STAFF REPORT AMENDED 9-27-84
CITY PLANNING COMMISSION

- APPLICATION:
- A. Negative Declaration
 - B. Schematic Plan Amendment to delete restaurant designation and add office designation
 - C. Amendment to PUD Guidelines to reduce 25' landscaped setback along a portion of Norwood Avenue to 12'
 - D. Special Permit to construct a 50,000 sq. ft. office structure
 - E. Lot Line Merger to create a lot totalling 4.3+ acres in the Light Industrial (M-1(S)) and General Commercial (C-2) zones

LOCATION: 3950 Research Drive

PROPOSAL: The applicant is requesting the necessary entitlements to construct a 50,000+ sq. ft. office building to house the Sacramento County Welfare and Health office.

LANDSCAPE PLANS

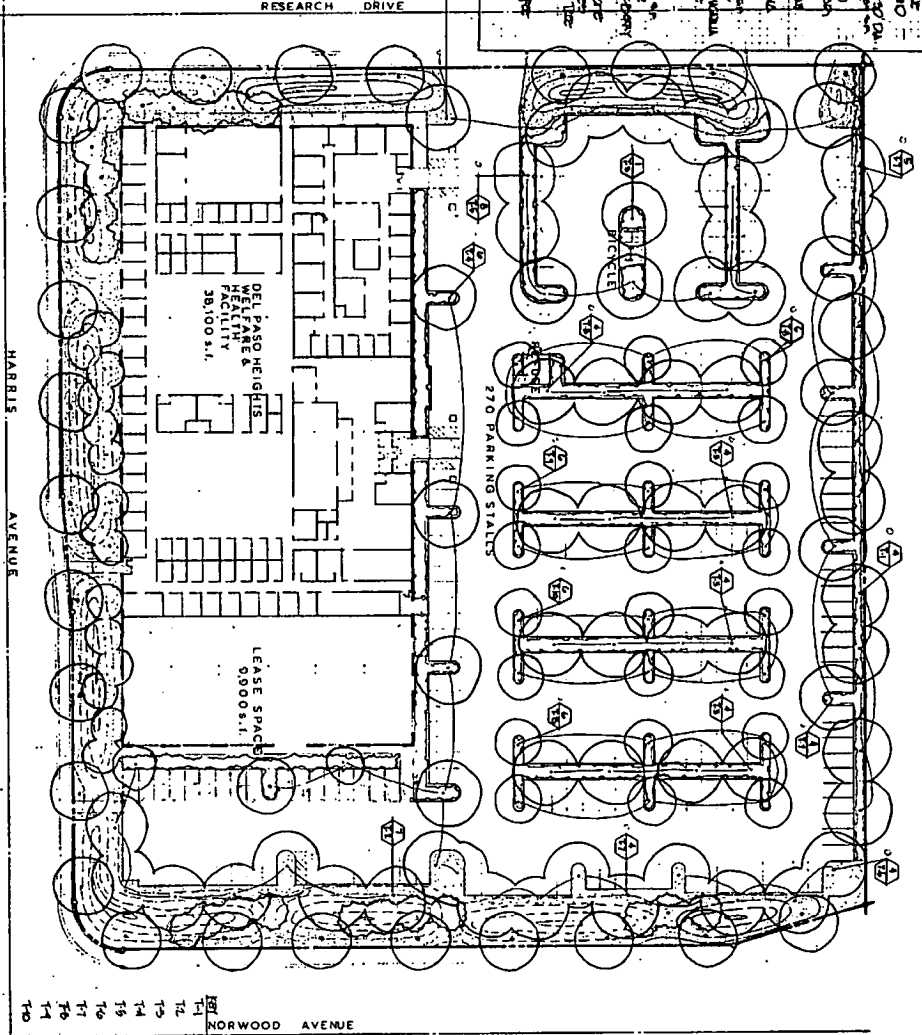
The site plan proposes a perimeter landscape strip which vary in width from 26' to 32'. The PUD guidelines require a minimum landscape setback of 25 ft.

The landscape setback at the northeast corner of the subject site proposes a 12 ft. landscape setback from Norwood Avenue property line. This portion of the parcel was reduced in size when the I-80/Norwood off-ramp was constructed. The applicant is proposing to compensate for this reduction by increasing the width of the landscape setback along the south half of the site from 25' to 32'. The applicant has requested an amendment to the PUD Guidelines to allow the proposed landscape plan. Staff has no objection to this request.

The staff suggests that the parking stall depth be reduced from 17', as proposed, to 16' with the difference placed in the landscape median strip.

The revised landscape plan shall also include a minimum 4' wide perimeter landscape strip between the building wall and sidewalk.

The staff requests that the landscape setback areas adjacent to the public streets and around the perimeter of the building between the building wall and sidewalk be intensively planted with a combination of deciduous and evergreen trees, ranging in size from 24" box specimen and 15 gallon trees.

A revised final site plan incorporating the above changes shall be submitted to the Planning Director for review and approval prior to issuance of building permit.

- b. All landscape setback areas adjoining the public streets shall be a minimum width of 25 ft. except for a portion of lot 3.
 - c. Parking stall depth shall be reduced to 16 ft. with the difference placed in the landscape median strip.

- d. A four foot wide building perimeter landscape strip shall be installed between the building wall and sidewalk.
 - e. A minimum 75% of all landscaped setback areas shall be planted with lawn with a combination of deciduous and evergreen trees (24" box specimen and 15 gallon trees) planted in the setback areas.

ELEVATIONS

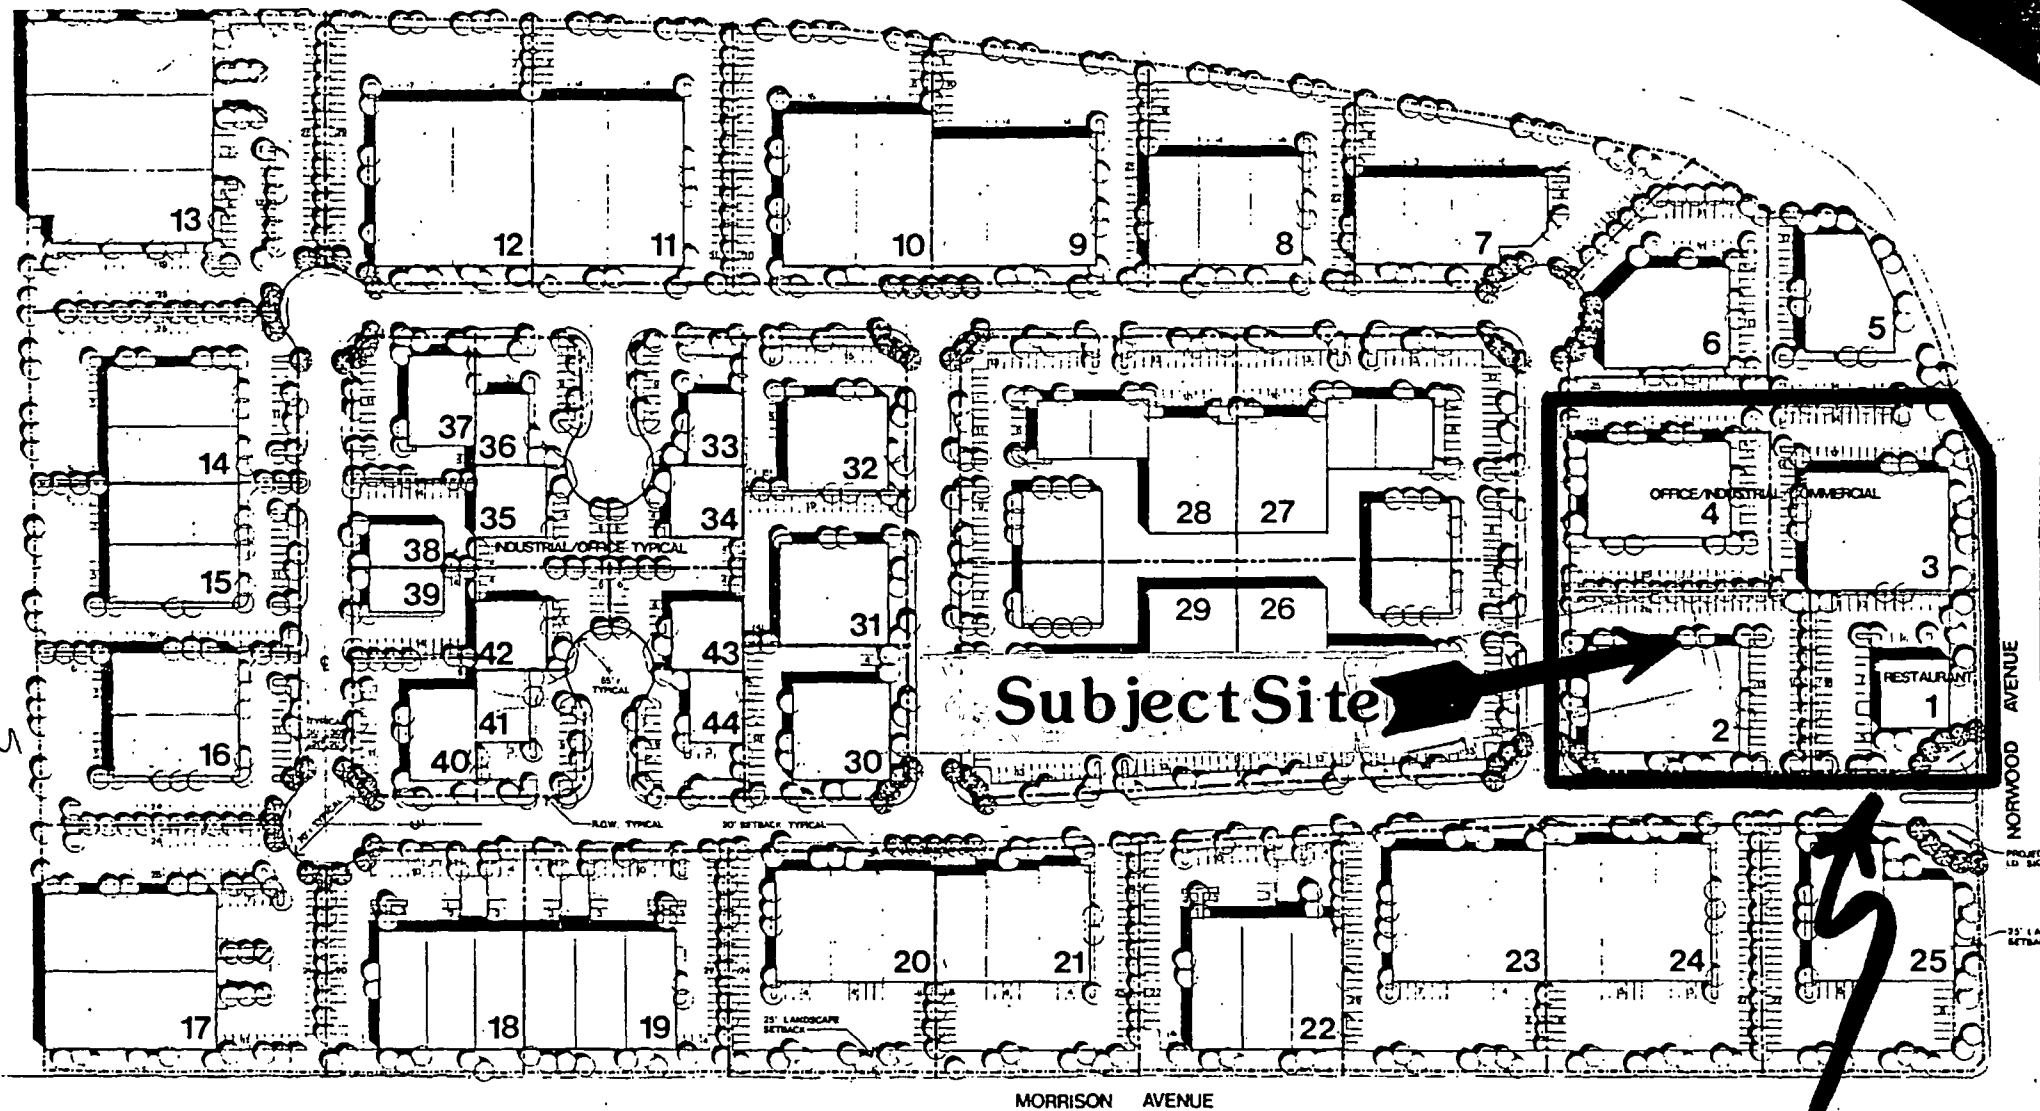
The applicant proposes to construct a one-story, 48,600 sq. ft. office building using tilt up concrete panels with tex-coat finish and flat concrete roof tiles. The staffs major concern is related to the flat uninterrupted facade of the building and its incompatibility with adjacent buildings in the PUD.

Several of the new industrial buildings in the area use similar tilt-up concrete panels but incorporate pattern, texture and reveal lines into the facade. The staff met with the applicant to discuss proposed design modifications.

The applicant has agreed to redesign the building to address these concerns. A new design using pre-cast concrete panels with exposed aggregate texture, strong vertical fluted pattern, horizontal color band, and recessed window walls to break up the flat facade was proposed as an alternative design. The proposed redesign will be more compatible with the newer, better designed office/industrial buildings in the business park.

The applicant shall submit revised elevation plan of the proposed office building for the review and approval of the Planning Director prior to issuance of building permit.

- a. The facade of the building shall be exposed aggregate panels with sections incorporating deep vertical fluting. Door entrance areas and sections of window walls shall be recessed sufficiently to provide visual break-up of the flat surface plane. ~~A parapet wall shall be constructed to screen any roof top mechanical equipment.~~ (CPC amended)
The height of the ^{mansard roof} ~~parapet wall~~ shall be sufficient to screen any roof top mechanical equipment. (CPC amended)
